Safety Defect and Noncompliance Report Guide for Vehicles
PART 573 Defect and Noncompliance Report¹

SERVICE ADVISORY # 05-061

Laredo Battery Compartment Wiring

Models Included: 2006 Laredo Travel Trailers and Fifth Wheels

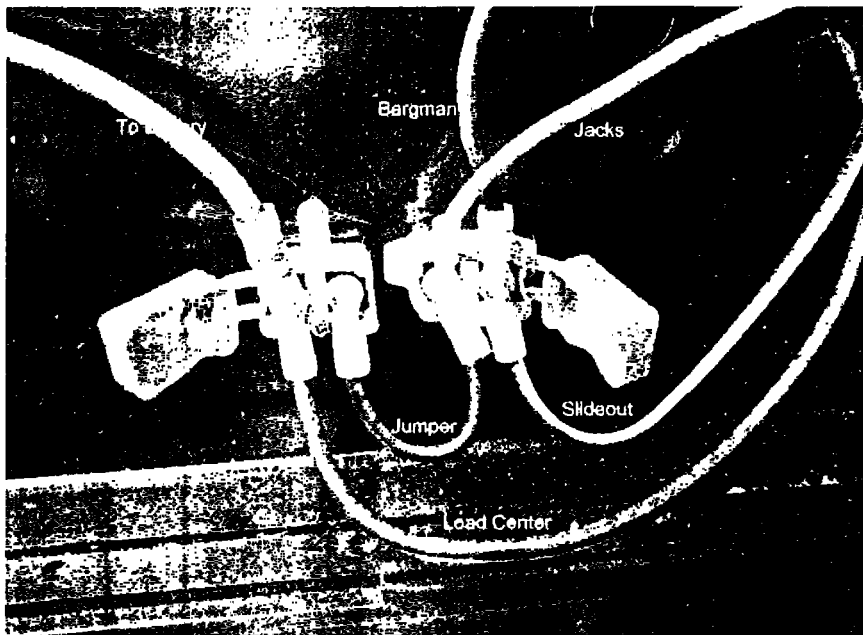
Wires in the battery compartment from the circuit breakers may be wired to the unprotected side of the circuit breaker. This creates a potential fire hazard should the wire become shorted.

Step 1: If the circuit breaker wire connections look like the picture below then a change needs to be made. Note that the Battery wire is located so that the Load Center wire is unprotected by the 30 amp circuit breaker.
